Re: PD Plan & Preliminary Plat, Centerstate East Subdivsion (Minor Amendment)

By means of this letter I am approving your request for a minor amendment to the PD development plan known as the, "PD Plan & Preliminary Plat, Centerstate East Subdivision", bearing your seal dated October 17, 2025.

PD PLAN & PRELIMINARY PLAT - PLAT

Clinton.Smith@CoMo.gov

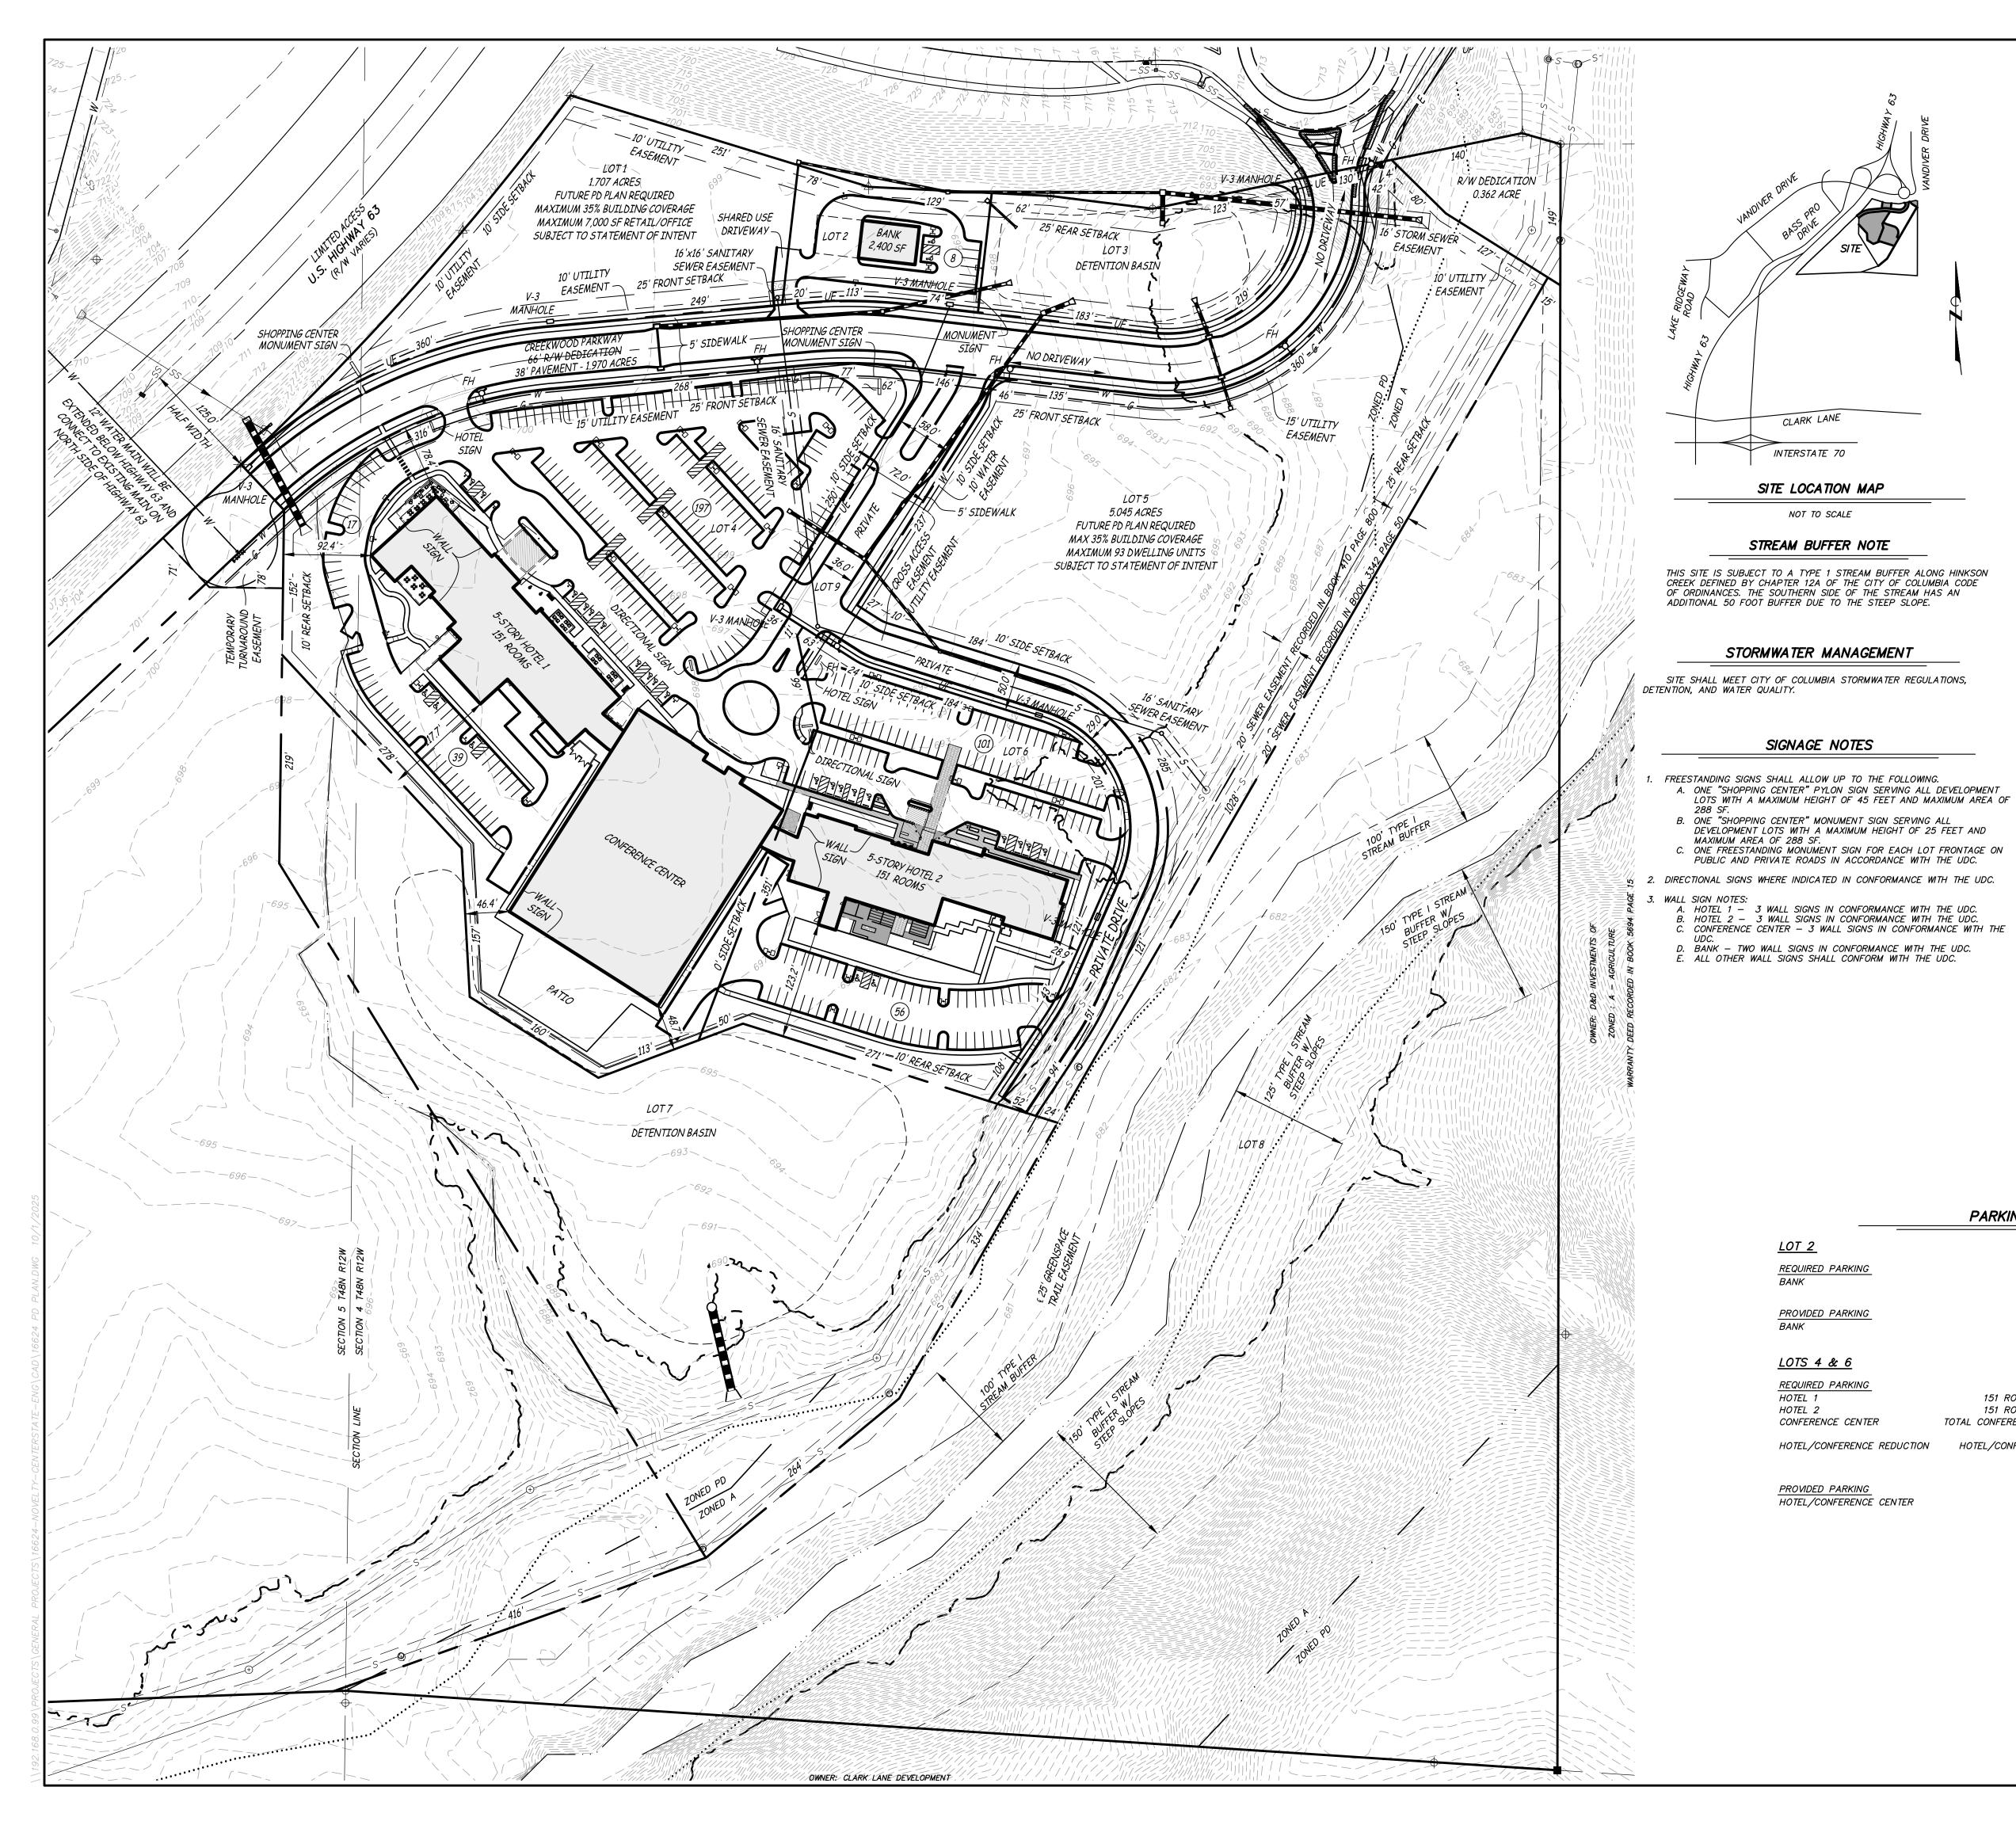
- 1. Common stormwater management added to Lot 3.
- 2. East boundary of Lot 5, 6, 7, and 10 moved to match east edge of existing sanitary sewer easements. Sewer easements are now outside preservation lot.
- 3. Revised Creekwood Parkway alignment for design speed.
- 4. Utility lines & easements have been updated to maintain 10-ft separation from water lines and prevent water lines from running parallel under pavement.
- 5. Sanitary sewer location has been updated to serve Lots 1 and 2.
- 6. Improvements on Lot 5 & 6 rotated to eliminate potential impact to wetlands along Hinkson Creek.
- 7. Additional landscape islands were added within Lot 5 and 6 parking lots.
- 8. Tree plan updated to match Infrastructure plan with additional surveyed trees.
- 9. Corrected floodplain limits.
- 10. West line of Lot 7 simplified.
- 11. Lot lines and areas revised to accommodate these revisions.
